**SUBJECT:** **R.E. Ginna Nuclear Power Plant**  
Docket No. 50-244

Application to Revise Technical Specifications Regarding Control Room  
Envelope Habitability in Accordance With TSTF-448, Revision 3, Using the  
Consolidated Line Item Improvement Process

## **Attachment 1**

## **Attachment 2**

Figure B 3.7.9-1  
CREATS

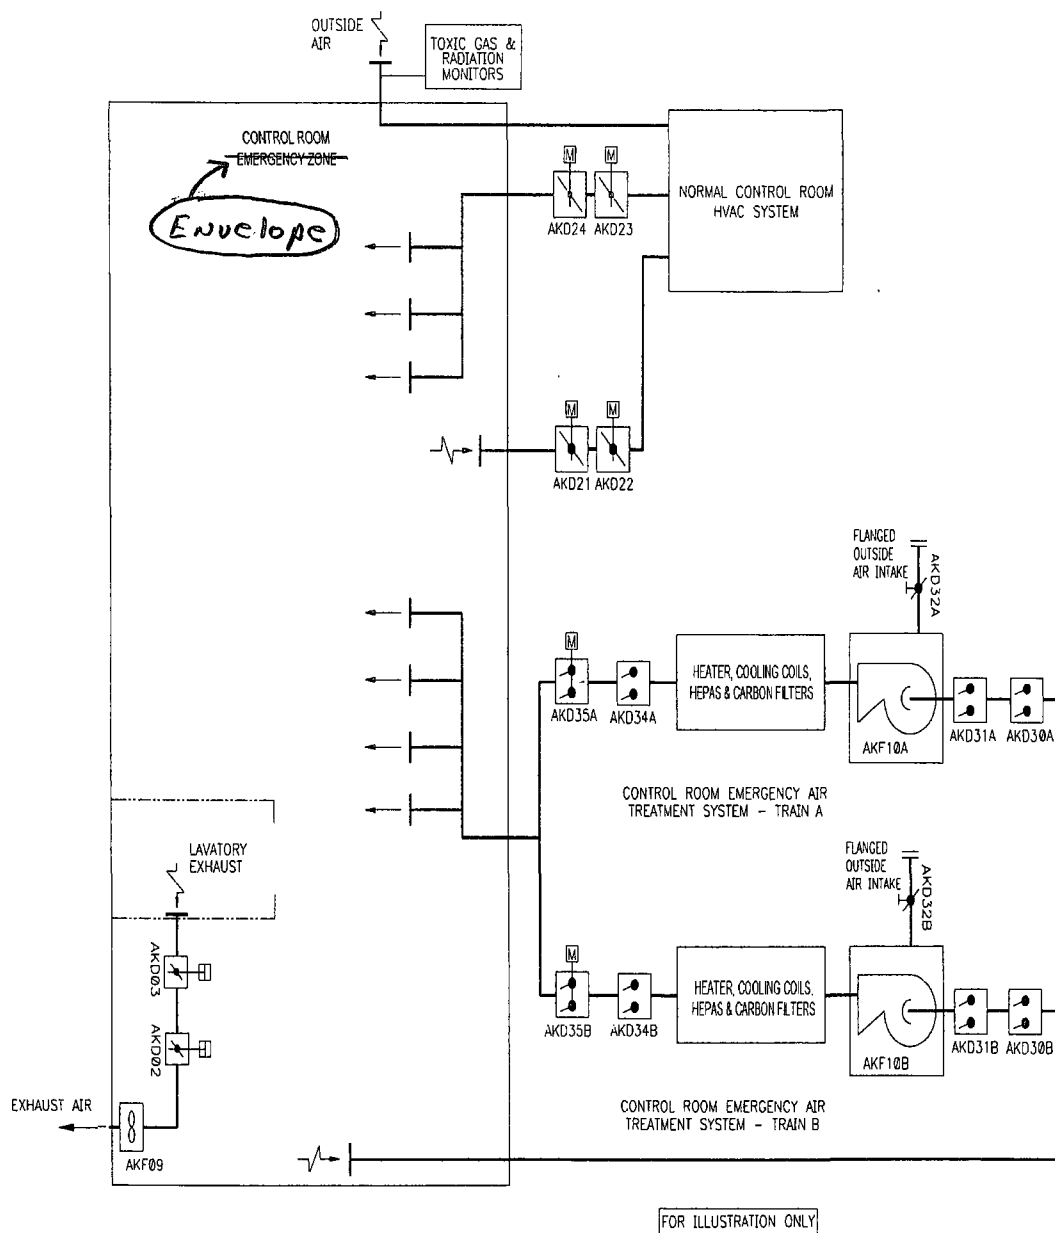
The CREATS consists of two trains, each containing a high efficiency particulate air (HEPA) filter, activated charcoal adsorbers for removal of gaseous activity (principally iodines), and one fan (see Figure B 3.7.9-1). Ductwork, dampers, and instrumentation also form part of the system (Ref. 3).

~~The CREATS is considered OPERABLE when the individual components necessary to permit CREATS operation are OPERABLE (see Figure B 3.7.9-1). A CREATS train is OPERABLE when the associated:~~
